RE: Atlantic Coast Pipeline - Review of June 1, 2017 Submittal in Response to Request for Information

Atlantic Coast Pipeline

DEQ Review Comments – Request for Additional Information

Dominion Atlantic Coast Pipeline Dye Tracing Recommendations

Figure 9. Gardner Spring and ACP Karst

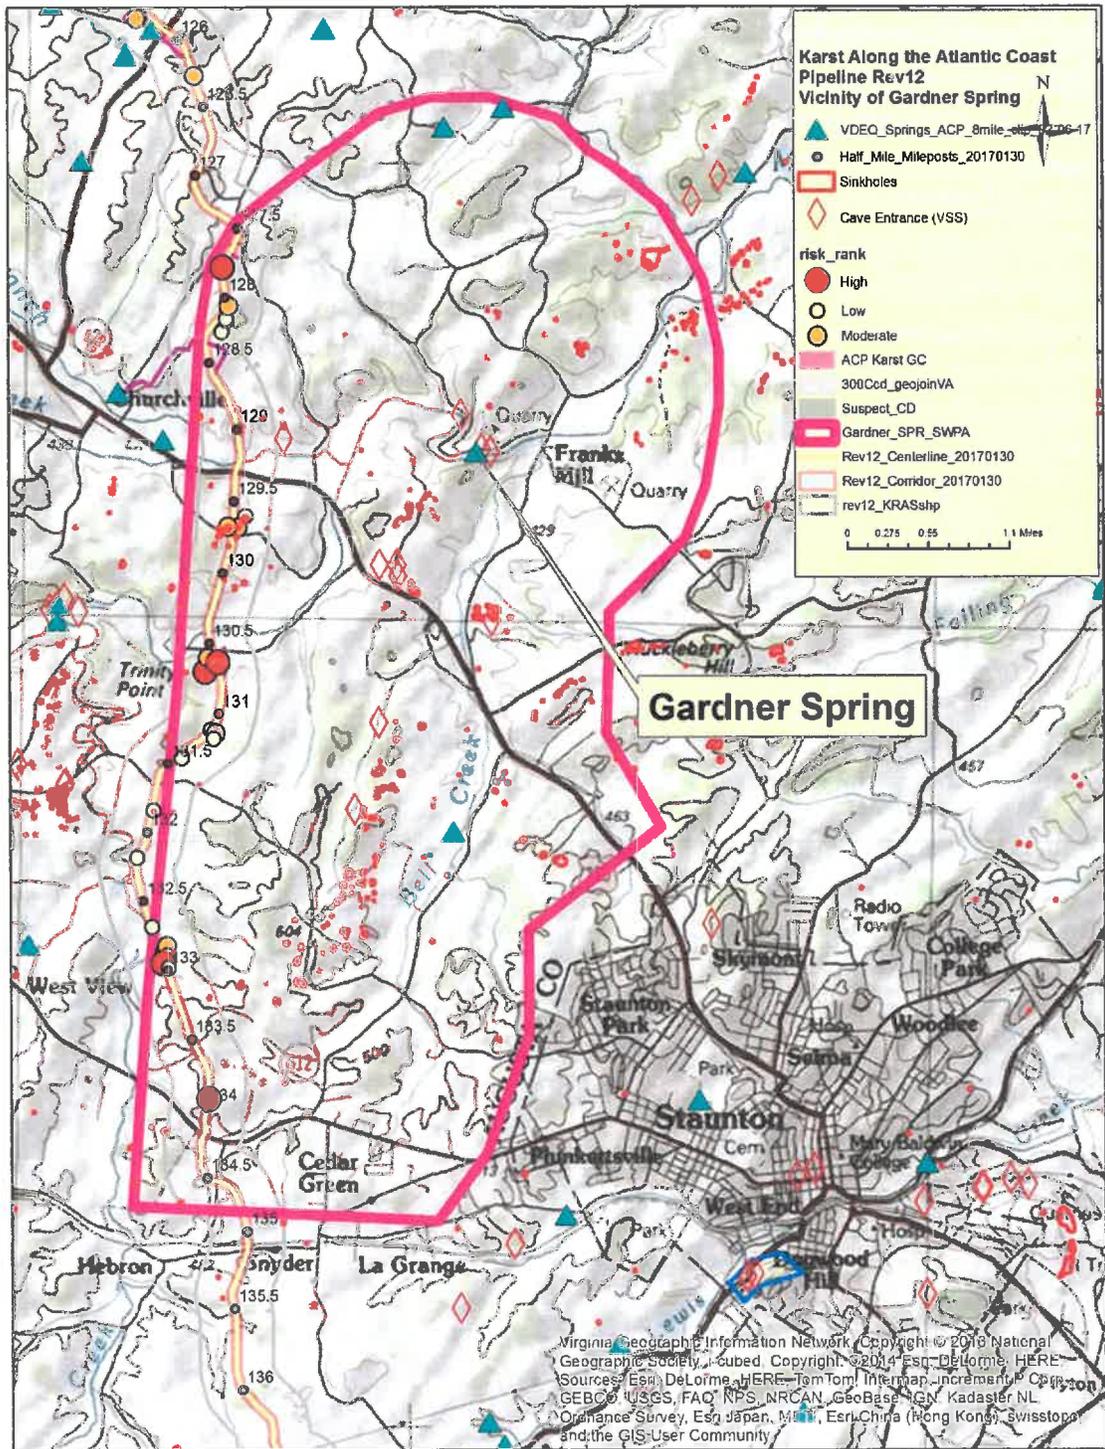
8) Gardner Spring

The area of land disturbance for the ACP passes within approximately 1.5 miles of Gardner Spring, a significant public water supply in Augusta County. As shown in figure 9, the Rev12 corridor skirts the western edge of the source water protection area for Gardner Spring as delineated by Emery and Garrett Groundwater, Inc for the Augusta County Public Service Authority. Geoconcepts has mapped 5 high risk and 8 moderate risk features in this area. Dye tracing should be used as an attempt to determine if and how closely the mapped features are connected to Gardner Spring. If no positive recovery of dye is made, it should be assumed these features may be connected to Gardner Spring for purposes of spill response. Three to six dye injections may be necessary for adequate determination of potential connectedness of features on the Rev12 ROW to Gardner Spring. Investigations in this area should be performed in coordination with Joel Maynard of the Virginia Department of Environmental Quality.

Figure 10. High risk karst feature near Stuarts Draft

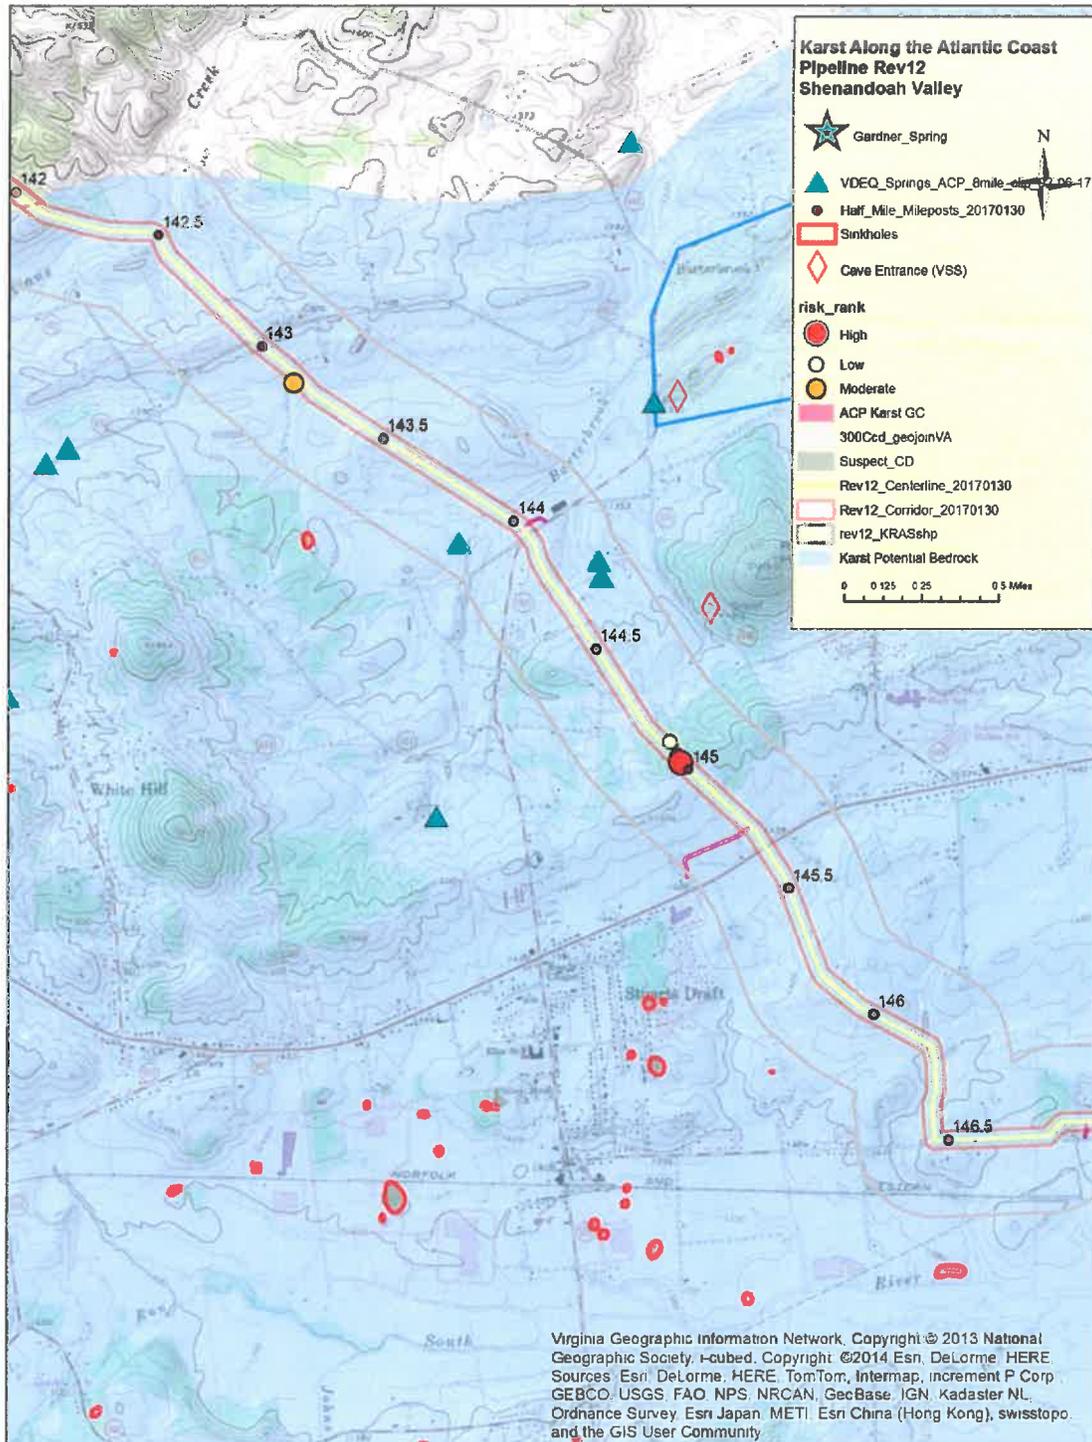
10) Stuarts Draft Feature.

The high risk karst feature at MP 145 (Figure 10) should be investigated for potential dye tracing. It appears to be on the northern slope of a bedrock ridge.
